Subject: **CHIQUITA CANYON LANDFILL (SWIS No. 19-AA-0052)  
CALRECYCLE'S REVIEW OF CONDITIONS AT THE LANDFILL  
Response Letter**

**Subject: Review Chiquita Canyon Landfill (19-AA-0052) Response Letter**

Figure 1. The reaction settlement area at the Chiquita Canyon Landfill. Red indicates one foot or more settlement between June 19, 2023, and July 21, 2023.

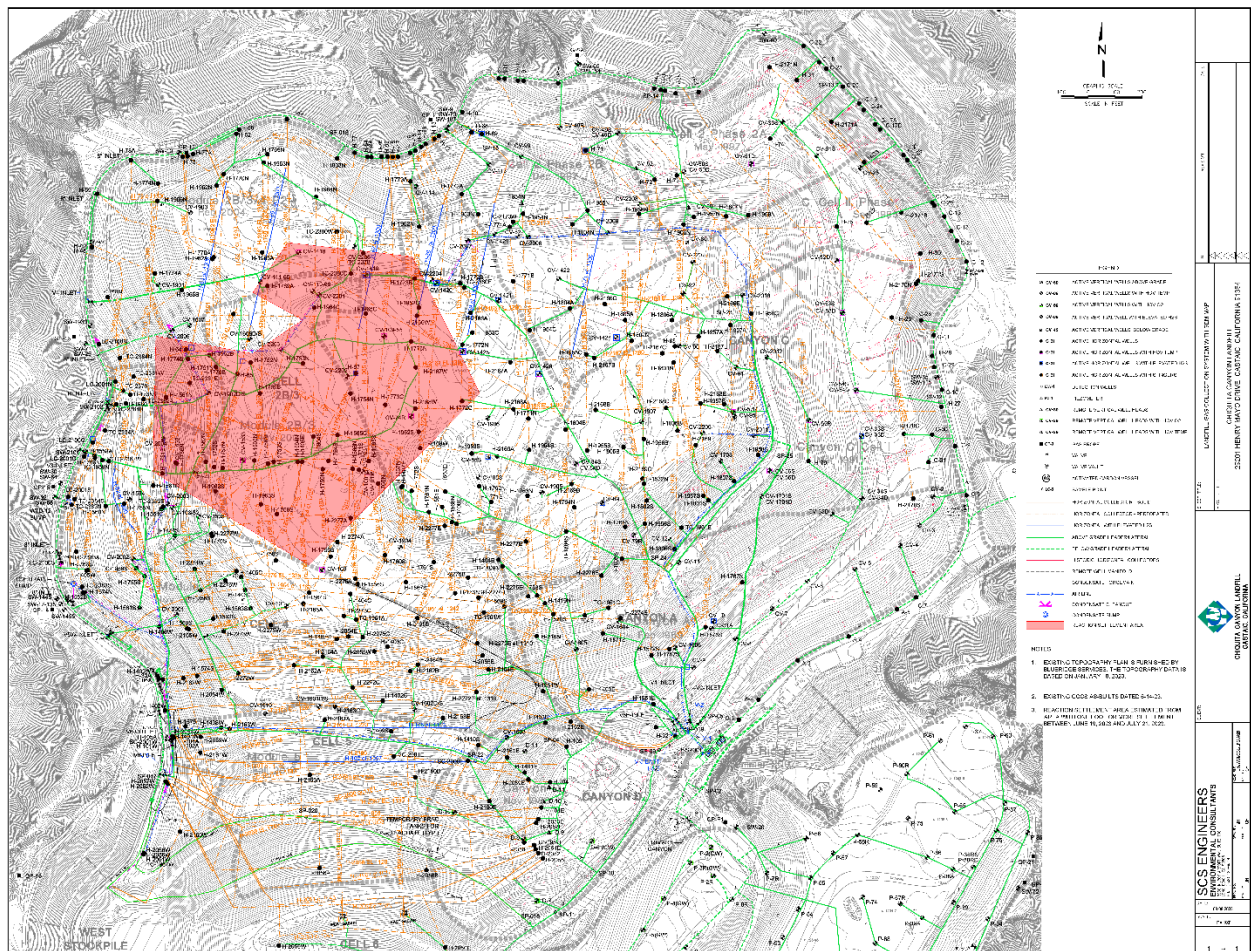
The two CCL reaction site maps from July 2023 and September 2023 show that the incident has expanded in all directions, most notably to the north and west. The approximate size of the incident now is between 30 and 35 acres.
